Project	IEEE 802.16 Broadband Wireless Access Working Group < http://ieee802.org/16 >	
Title	A New Primitive for Indicating Network Attachment	
Date Submitted	2006-11-15	
Source(s)	Jaesun Cha and Chulsik Yoon	jscha@etri.re.kr
	ETRI 161 Gajeong-dong, Yuseong-gu Daejeon 305-700 Korea	
Re:	Contribution on comments to IEEE 802.16g/D5	
Abstract	In this contribution, we propose a new primitive to infer NCMS of network attachment.	
Purpose	Adoption	
Notice	This document has been prepared to assist IEEE 802.16. It is offered as a basis for discussion and is not binding on the contributing individual(s) or organization(s). The material in this document is subject to change in form and content after further study. The contributor(s) reserve(s) the right to add, amend or withdraw material contained herein.	
Release	The contributor grants a free, irrevocable license to the IEEE to incorporate text contained in this contribution, and any modifications thereof, in the creation of an IEEE Standards publication; to copyright in the IEEE's name any IEEE Standards publication even though it may include portions of this contribution; and at the IEEE's sole discretion to permit others to reproduce in

Figure xxx – network attachment

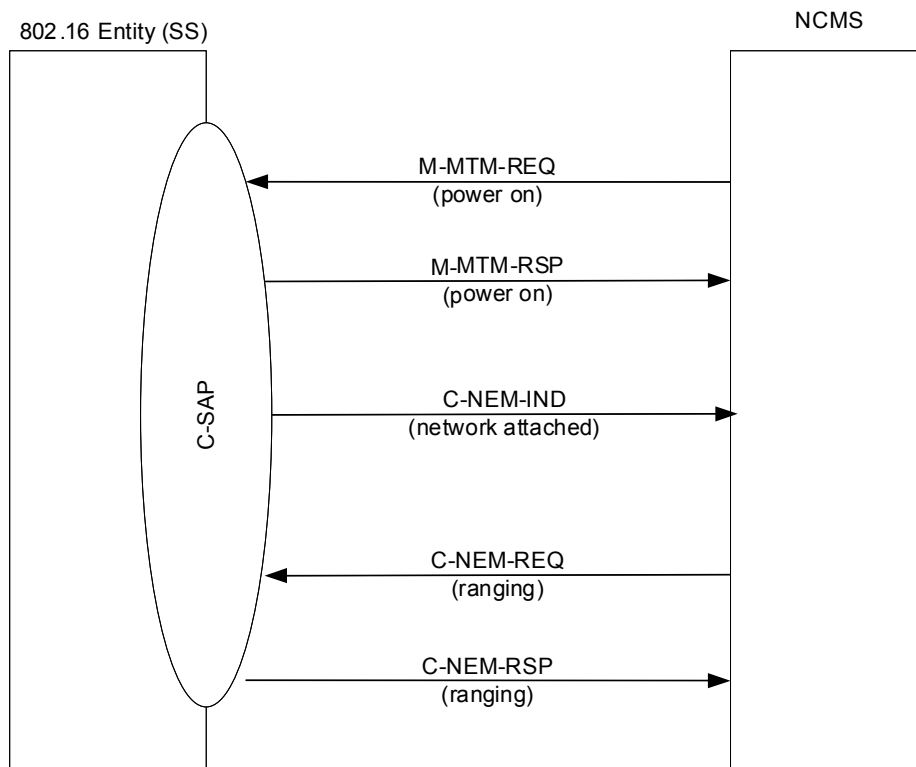
According to the current draft, NCMS shall issue M-MTM-REQ(power on) and C-NEM-REQ(ranging) primitives to activate 802.16 terminal. But, NCMS doesn't know when the 802.16 terminal is ready to perform ranging after it receives M-MTM-RSP(power on) primitive. After the 802.16 terminal is powered on, it shall scan for downlink channel, establish synchronization with a BS and obtain transmit parameters from UCD and DCD message before initial ranging. It will take a couple of seconds to complete aforementioned initialization steps because of transmission interval of UCD and DCD. Therefore NCMS can't issue C-NEM-REQ(ranging) right after it receive M-MTM-RSP(power on).

In this contribution, we propose a new control primitive which tell that 802.16 terminal is synchronized with BS and ready to perform initial ranging.

[Insert the following figure before subclause 14.2.81 on page 99]

14.2.8.4 C-NEM-IND

This primitive is used by SS to inform NCMS of the completion of initialization procedure which includes synchronization with the BS and acquirement of downlink/uplink transmission parameters.

This primitive is generated when the SS completes initialization steps and is ready to perform initial ranging.

NCMS can issue C-NEM-REQ (ranging) to request the SS to perform initial ranging after it receives this primitive.
